Service Bulletin

Bulletin No.: 22-NA-089

Subject: Intermittent Click Noise at Front of Vehicle, ABS, Traction Control System (TCS)/ Stabilitrak Lamps May Illuminate Intermittently and/or Deactivate for Ignition Cycle - DTC P215B, C0035-C0051 Set

Brand:	Model:	Model Year:		VIN:		Engine:	Transmission:
		from	to	from	to		
Chevrolet	Bolt EV	2017	2019	—	—	—	—

5317528

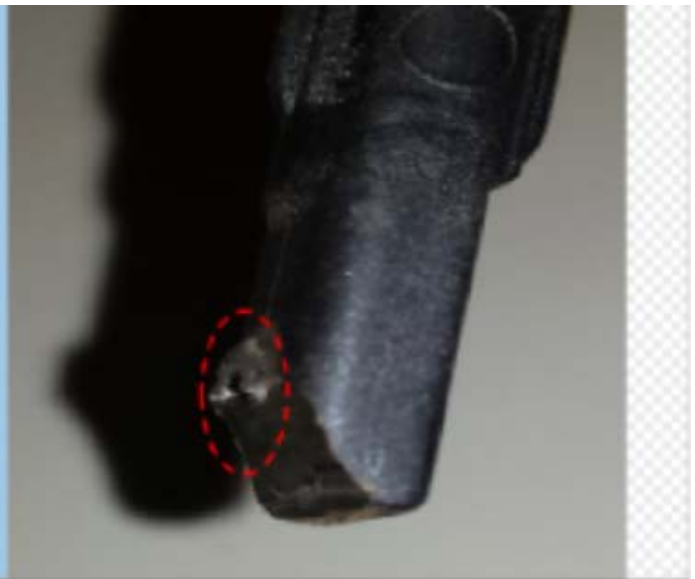
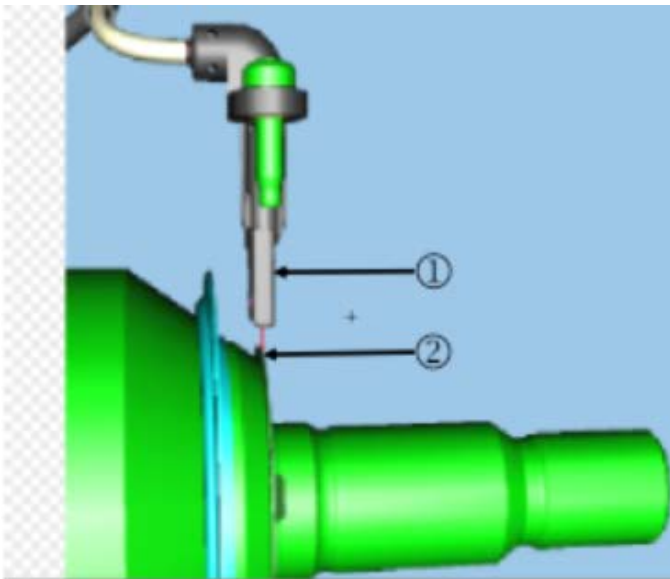
Important: DO NOT install any anti-click washer.

2. Remove the anti-click washer (1) from the outboard joint of the half shaft (2) and discard.
3. If affected, repeat steps #1 and #2 on the opposite side.

5317529

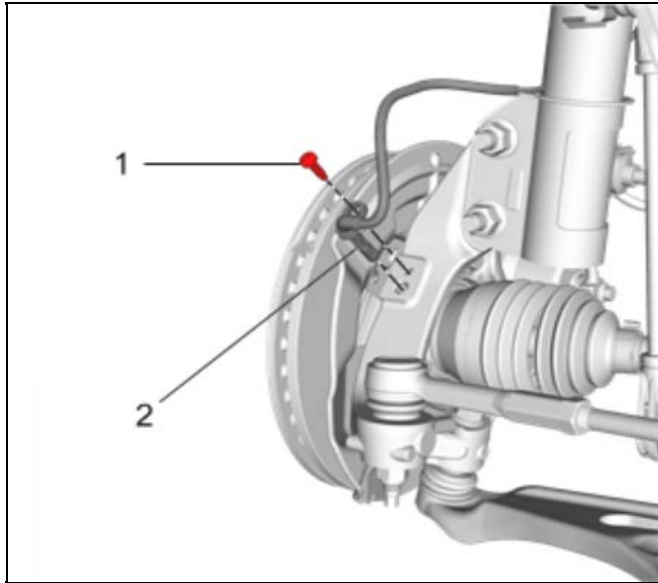
Note: The example above depicts the wheel speed sensor (WSS) (1) directly in-line with the anti-click washer (2) on the outboard joint of the half shaft.

4. Inspect the WSS on either/both affected side(s) for possible damage. It may be damaged due to contact with the oversized damaged washer.
 - If no damage is found, reinstall the lower control arm to the steering knuckle, and no further repairs are necessary.

- If the WSS is found to be damaged (as shown circled in the graphic above), continue ahead to step # 5.

5. Replace any damaged front WSS (2). Refer to *Front Wheel Speed Sensor Replacement* in the Service Manual.
6. Install the lower control arm to the steering knuckle. Refer to- *Front Wheel Drive Shaft Replacement* in the Service Manual.
